APPENDIX A

Technical Specification Markups

APPENDIX B

Operating License Markup

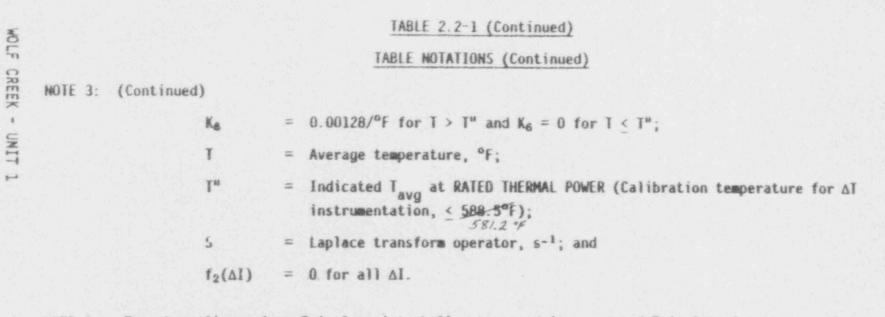
and $f_1(\Delta I)$ is a function of the indicated difference between top and bottom detectors of the power-range neutron ion chambers; with gains to be selected based on measured instrument response during plant STARTUP tests such that:

- (i) for $q_t q_b$ between -27% and + 7%, $f_1(\Delta I) = 0$, where q_t and q_b are percent RATED THERMAL POWER in the top and bottom halves of the core respectively, and $q_t + q_b$ is total THERMAL POWER in percent of RATED THERMAL POWER;
- (ii) for each percent that the magnitude of $q_t q_b$ exceeds -27%, the ΔT Trip Setpoint shall be automatically reduced by 1.57% of its value at RATED THERMAL POWER; and
- (iii) for each percent that the magnitude of $q_t q_b$ exceeds +7%, the ΔI Trip Setpoint shall be automatically reduced by 0.85% of its value at RATED THERMAL POWER.

NOTE 2: The channel's maximum Trip Setpoint shall not exceed its computed Trip Setpoint by more than 2.6% of ΔT span. 2.5%

NOTE 4: The channel's maximum Trip Setpoint shall not exceed its computed Trip Setpoint by more than 3.7% of AT span. 2.8%
